AEA Appendix 4

**Effects to Unarmored
Threespine Stickleback**

Subject: **Engineering Review of Take Avoidance of Unarmored Threespine Stickleback Proposed Bridges and Flood-Control Facilities on the Santa Clara River Newhall Ranch Resource Management and Development Plan/Spineflower Conservation Plan Additional Environmental Analysis**

Subject: **Analysis of Impacts to Unarmored Threespine Stickleback for the Draft
Additional Environmental Analysis of the Newhall Ranch RMDP/SCP**

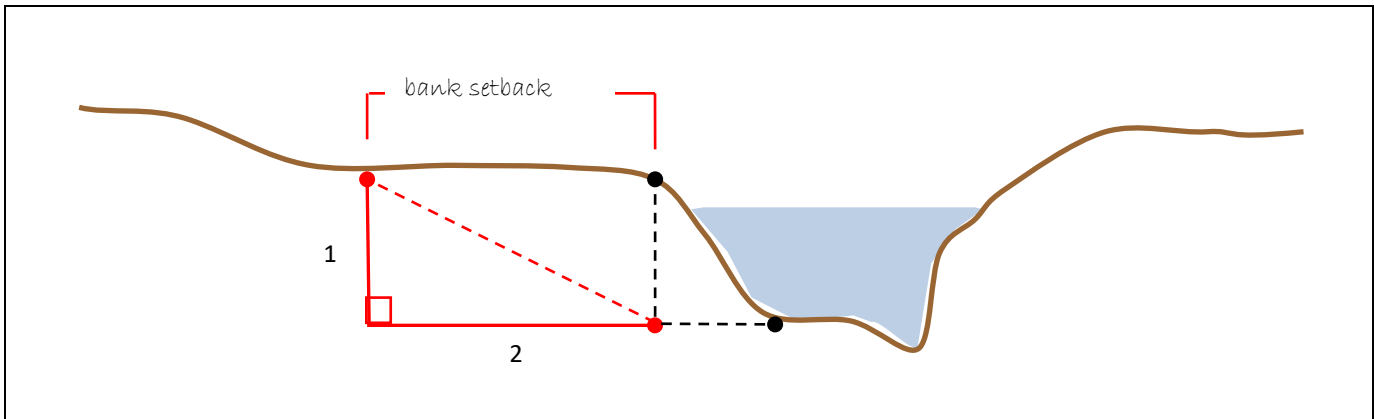
A potential geotechnical outcome of the installation of temporary haul route bridges is streambank instability triggered by construction activities and vibrations associated with installation of HP piles and possibly traffic vibrations during haul operations. The banks of the low-flow channel generally appear gently to moderately sloping and stable under low-flow conditions. The proposed minimum setback of 10 feet of the pile driving operations from the bank of the low-flow channel could allow sufficient space to protect banks of the wetted channel from construction activities (e.g., pile installation/removal) depending on actual site conditions. However, the engineering basis for the 10-foot setback is not clearly stated in the available studies and may be appropriate under certain, site-specific conditions. Figure 1 illustrates a bank setback strategy that could be employed to protect bank stability and applied to actual field conditions. The streambank protection area could be the greater of 10 feet or the distance indicated by evaluating the bank setback based on Figure 1.
